SUBJECT: Outboard Empennage Attach Fittings on some production M20R and M20TN Aircraft and procured through Mooney Service Parts.

MODELS/ SN Mooney M20R - Serial Numbers 29-0513 thru 29-0519

AFFECTED: Mooney M20TN - Serial Numbers 31-0101 thru 31-0127

TIME OF COMPLIANCE: **WITHIN NEXT 10 HOURS OF FLIGHT**

Figure SB M20-318-1 - EMPENNAGE TRIM ATTACH FITTING INSPECTION AND REPLACEMENT

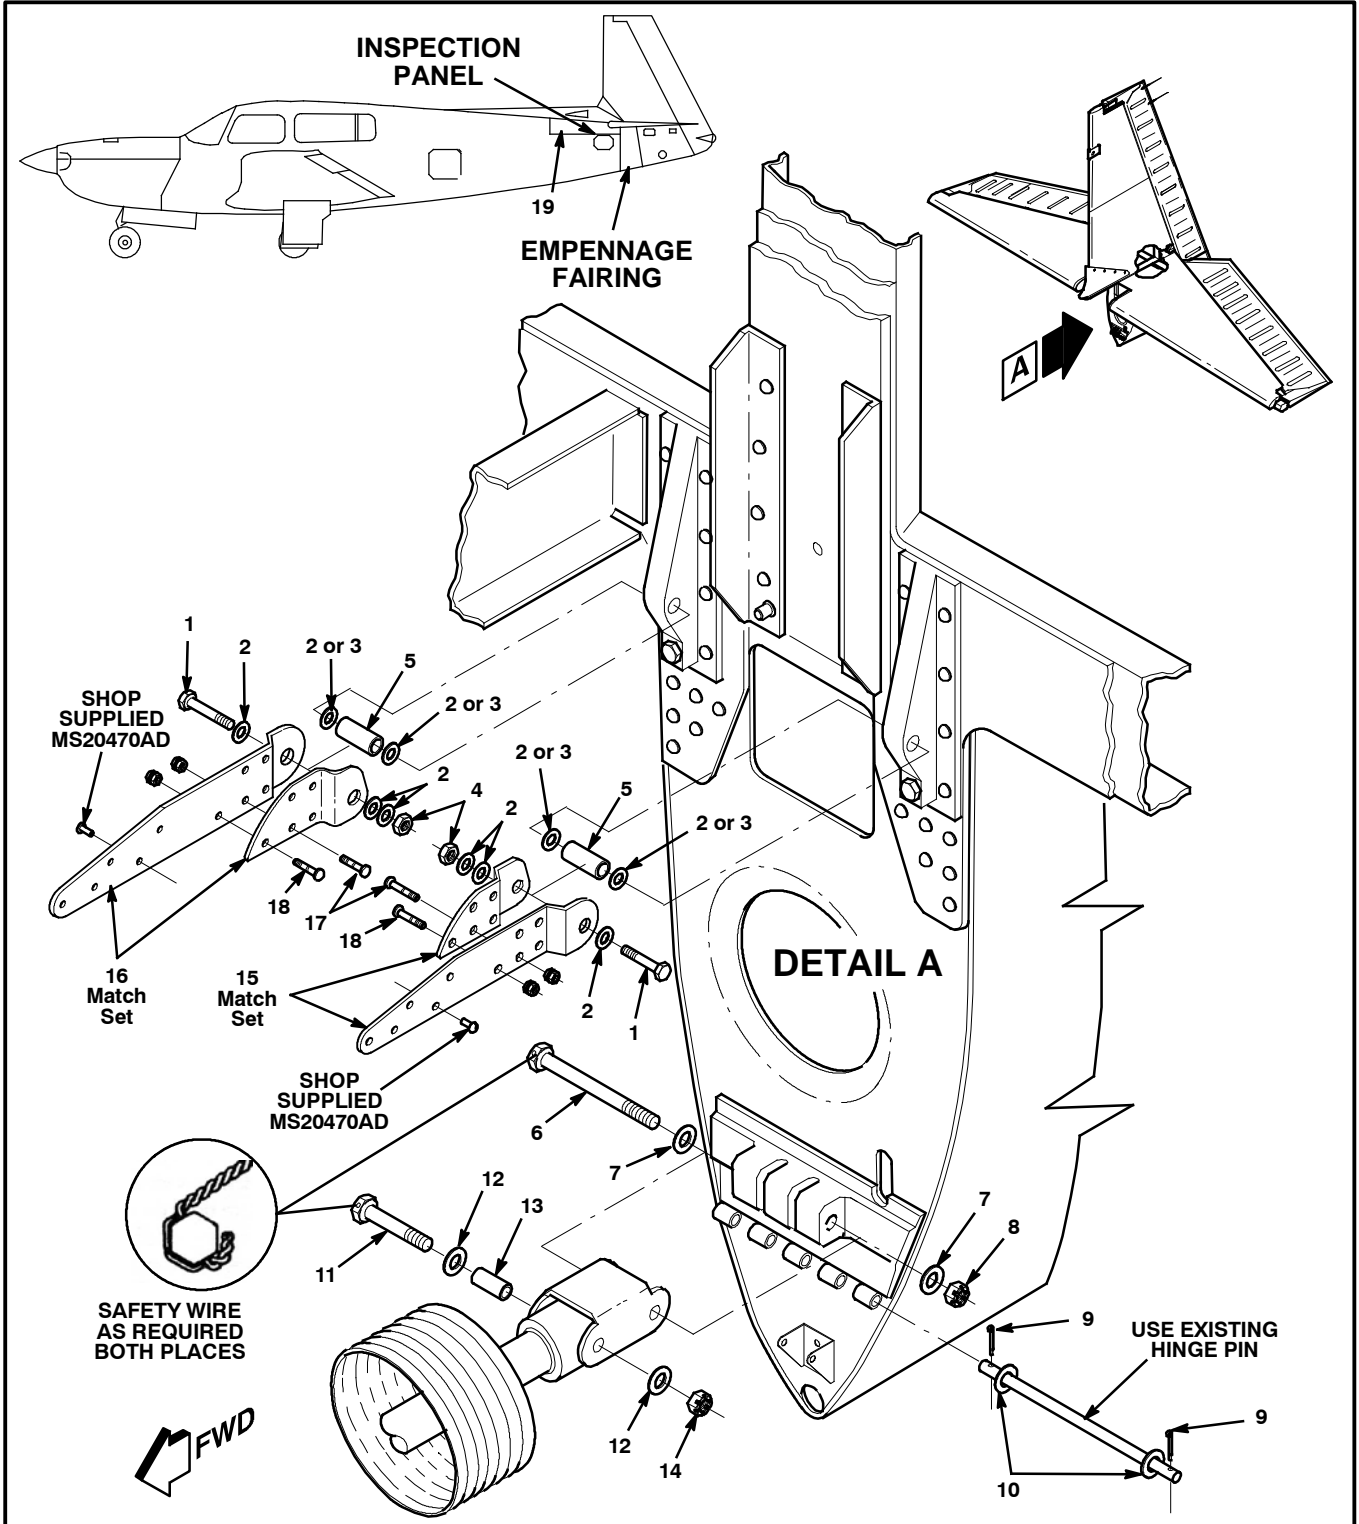
- 1.7. Reinstall Empennage Assembly per applicable Mooney Service and Maintenance Manual refer to Chapter 53 with new mounting hardware found in the M20-318-001 Service Bulletin kit. Shim as required with NAS1149F0463P and NAS1149F0432P Washers. One minimum each end of 914081-003 Bushings, 3 total maximum per side (refer to Figures SB M20-318-1 & 2) - Proceed to Step 2.9 of this Service Bulletin.

- 2.8. Reinstall Empennage Assembly per applicable Mooney Service and Maintenance Manual refer to Chapter 53 with new mounting hardware found in the M20-318-001 Service Bulletin kit. Shim as required with NAS1149F0463P and NAS1149F0432P Washers. One minimum each end of 914081-003 Bushings, 3 total maximum per side (refer to Figures SB M20-318-1 & 2)

Figure SB M20-318-2 - EMPENNAGE TRIM ATTACH FITTING MEASUREMENT AND FIXTURE

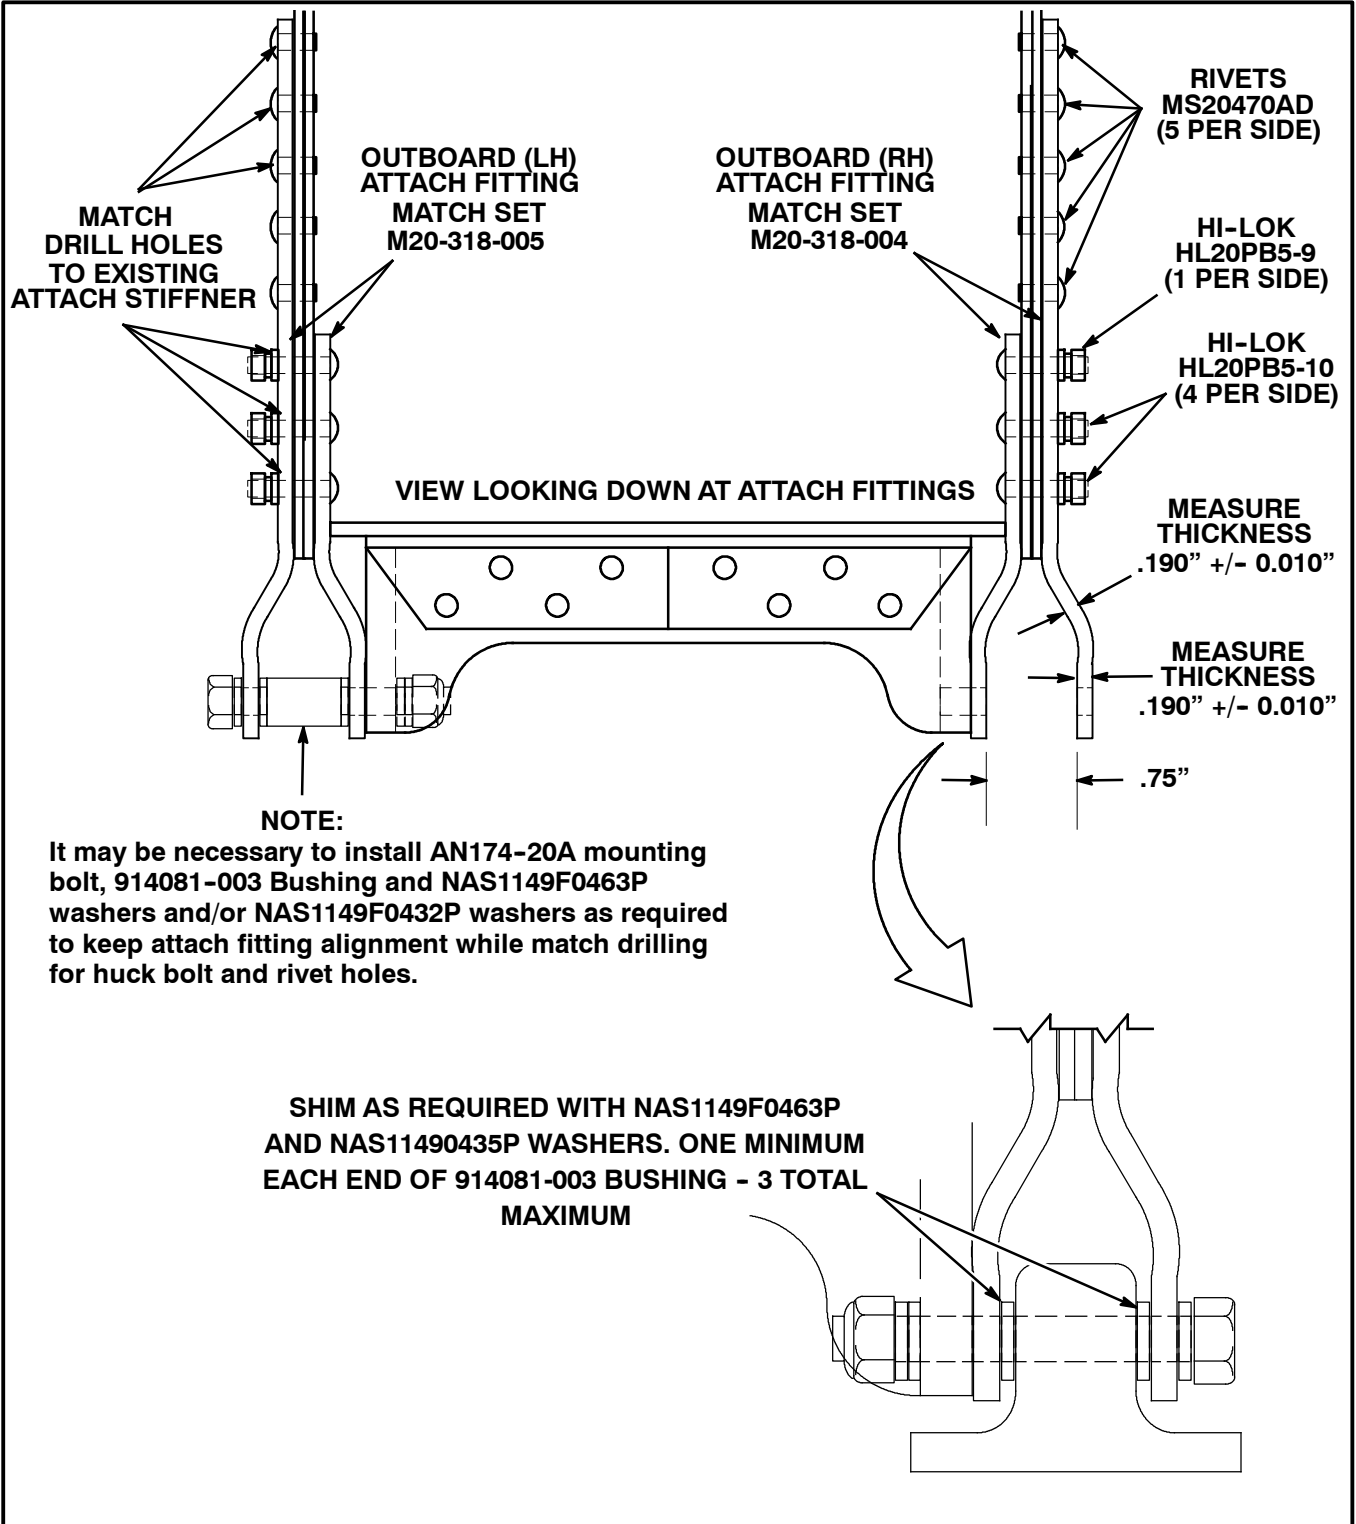
- 1.4. Measure thickness of each outer empennage attach fittings 350061-007 (LH) and 350061-008 (RH) with an appropriate micrometer or caliper. The thickness requirements are .190" +/- .010" (refer to Figure SB M20-318-2).

Figure SB M20-318-3 - TAILCONE SKIN REMOVAL

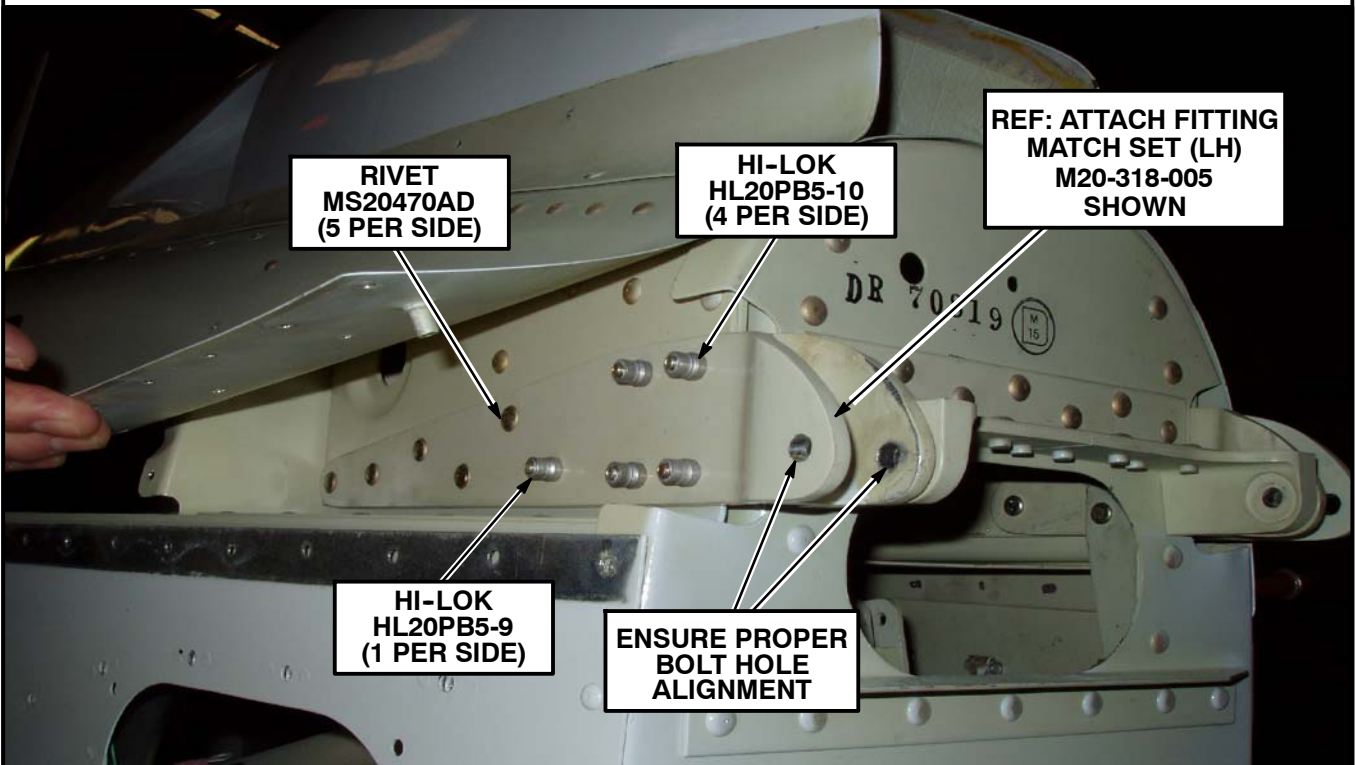
- 2.1. Remove tailcone fairing by drilling out Avex rivets 1691-0410 per section 51 of the applicable Mooney Service and Maintenance Manual, (refer to Figures SB M20-318-1 & 3).
- 2.2. Remove tailcone skin rivets MS20470AD (as required) to access the empennage attach fittings per section 51 of the applicable Mooney Service and Maintenance Manual, (refer to Figures SB M20-318-1 & 3).

- 2.5. Secure new parts with new rivets MS20470AD (qty 5 per side), Hi-Lok® P/N HL20PB5-10 Pins and HL86-5 collars (qty 4 per side) and Hi-Lok® HL20PB5-9 Pins and HL86-5 collars (qty 1 per side) into place as required, per the Hi-Lok® Installation instructions (refer to Figures M20-318-1 & 3).

- 2.6. Visually inspect all MS20470AD rivets and (10) Hi-Lok® fasteners to insure they are properly secured.
- 2.7. Reattach tailcone skin with new MS20470AD rivets and the tailcone fairing using 1691-0410 rivets as required per section 51 of the applicable Mooney Service and Maintenance Manual, (refer to Figures SB M20-318-1 & 3).
